Subject: Cs-137 gamma source, 3M Model 4D6M

The purpose of this correspondence is to place on file information relative to our Cs-137 gamma source, Model 4D6M. This source is to be fabricated for the Ohmart Corporation and included in one of their gauging systems. The Ohmart drawings which apply to this source are numbers A-11761 and B11760. Ohmart will be contacting you concerning the licensing of this source shortly.

Subject: Cs-137 Gamma Source, 3M Model 4F6S

2	AUG. 14, 1964	JDS	
	WAS WELDED		
	DELETE NOTE		
	WAS OHMART POINT SOURCE		
1	SEPT. 19, 63		
ISSUE	ISSUE DATE AND CHANGE RECORD	REV.	CH.
DIVISION STAFF LAB ENGR. PROJ.			
TITLE			
MODEL 4F65			
VOLUME SOURCE			
A	1921	78

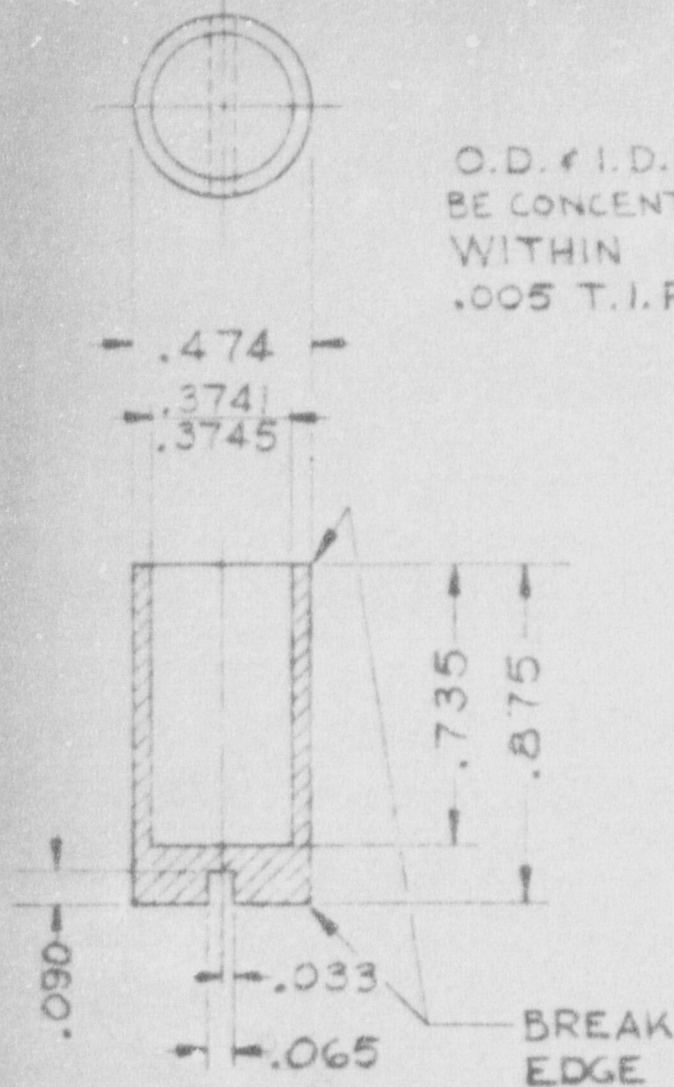
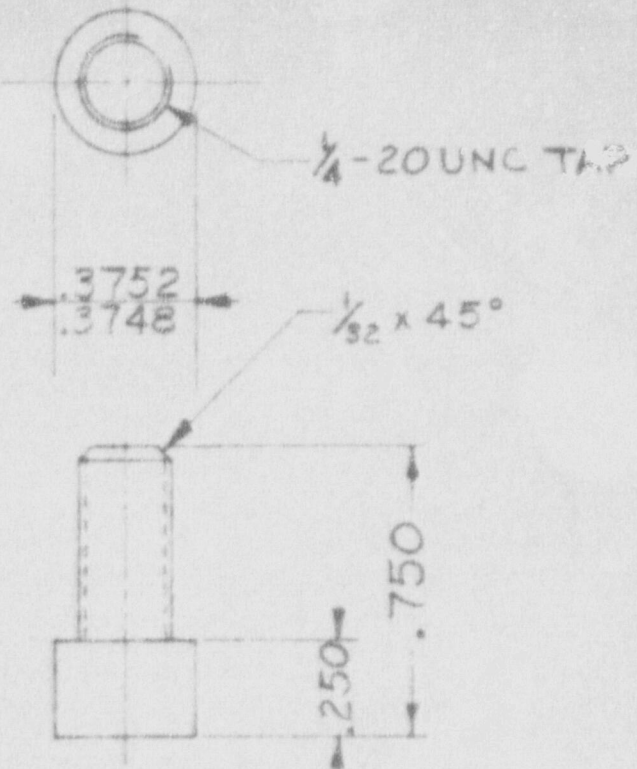
This responds to your letter dated August 14, 1964, containing information pertinent to your Model 4F68 sealed source. We note your comment that the dimensions given in your drawing No. A-1921-78 may vary. We request that you specify the minimum thickness of each wall of the two source capsules.

The minimum wall thicknesses for each of the two source capsules are as follows:

Side (circular) walls - 0.060"

End wall - 0.025"
